**Re: Parramatta Leagues Club Hotel (SSD 8800) – Response to Submissions**

# Response to Submissions (RtS) – Parramatta Leagues Club Hotel

**Figure 2 – Height Reduction (Original DA, left and current as revised, right, by Hassell)**

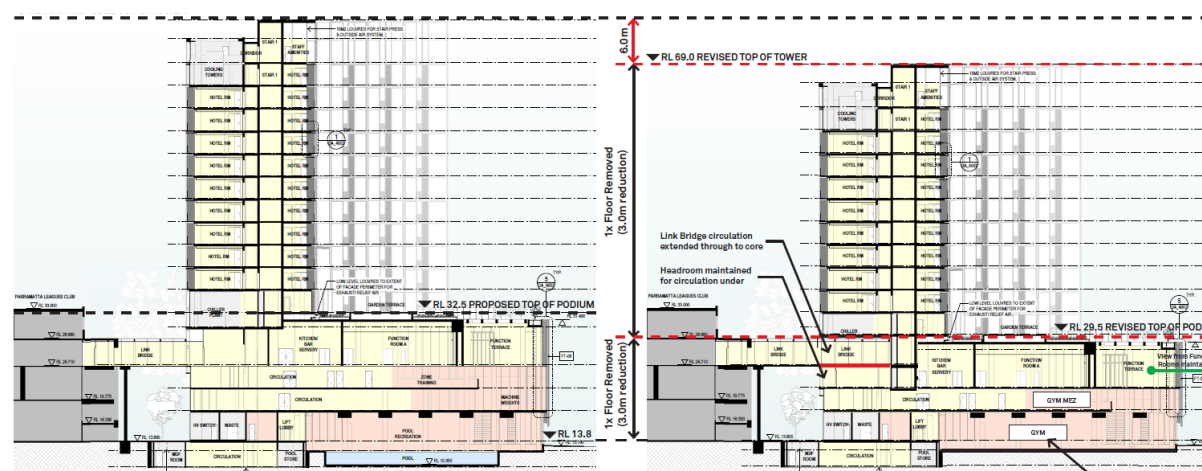
The main two changes to the proposal relate to the reduction by 6m (two levels) and change to the vehicular access to be from Eels Place to the west, rather than O’Connell Street to the south, via Venues NSW’s land.

The change in the building height is illustrated below:

**Figure 3** – Ground Floor and Access (Original DA, left and current as revised, right, by Hassell)

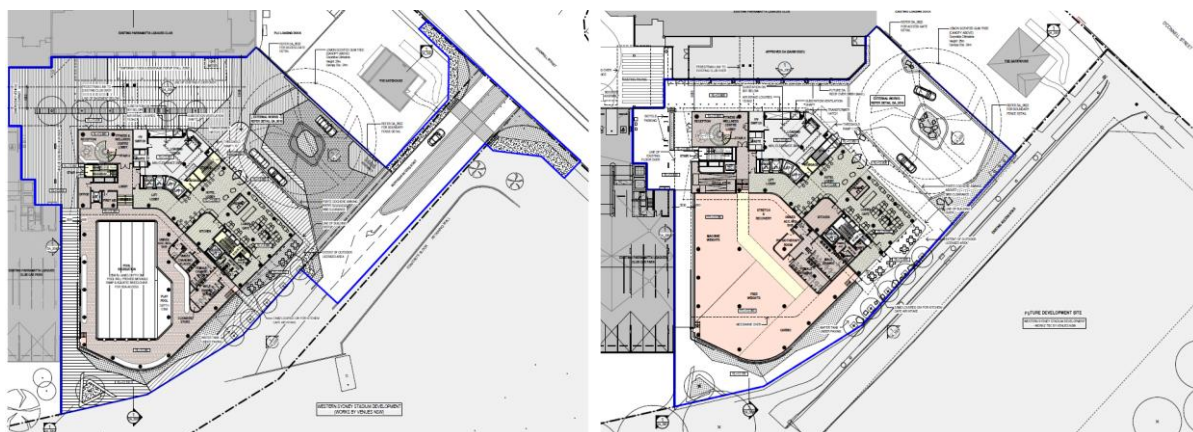
The change in vehicular access to/from the site is illustrated below:

The change in access no longer involves any works to VNSW land (i.e. part of the adjoining Stadium site), to the south. There is also some change to the ground floor access arising from the recent DA approval of a ground floor extension to the adjoining Parramatta Leagues Club Building (DA 681/2021, approved by Parramatta City Council), to the immediate north of the proposed hotel building. This has not yet been constructed, although is shown on plans on the basis it is intended to be built, and is approved.

**Figure 11 – Height Reduction (Original DA and as revised, Hassell)**

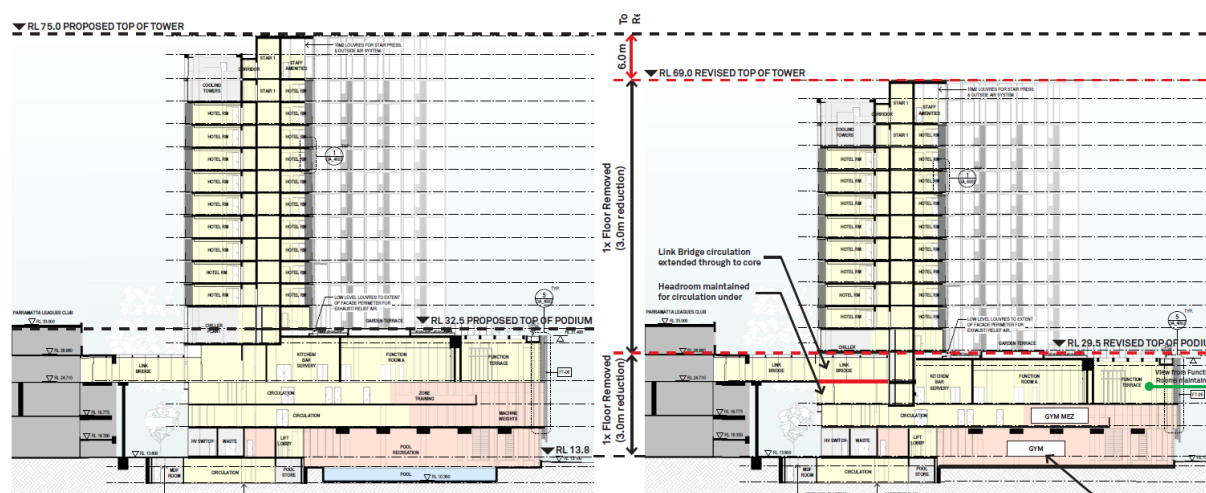
As previously outlined, the Building Height of the proposal has been reduced by 6m, equating to 2 storeys.

This has been achieved by deleting one level in the podium and one level in the hotel building above, with some consequential changes in floor-to-ceiling heights and plant rooms. This is illustrated below:

**Figure 21** – Ground Floor and Access (Original DA and as revised, Hassell)

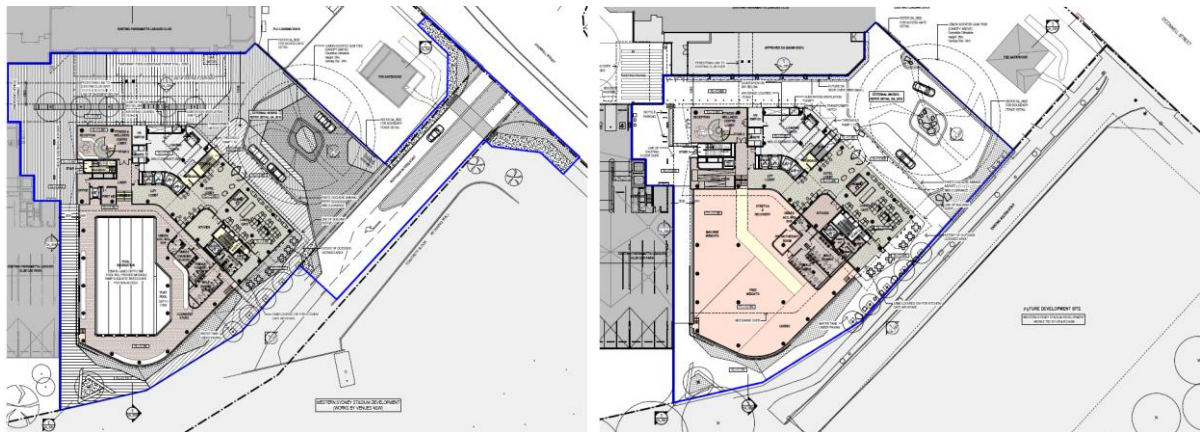
In terms of the access to and from the site, the proposal no longer relies on access over Venues NSW land to the south. All vehicular access is now from Eels Place. This is shown in the “before and after” floor plans below.
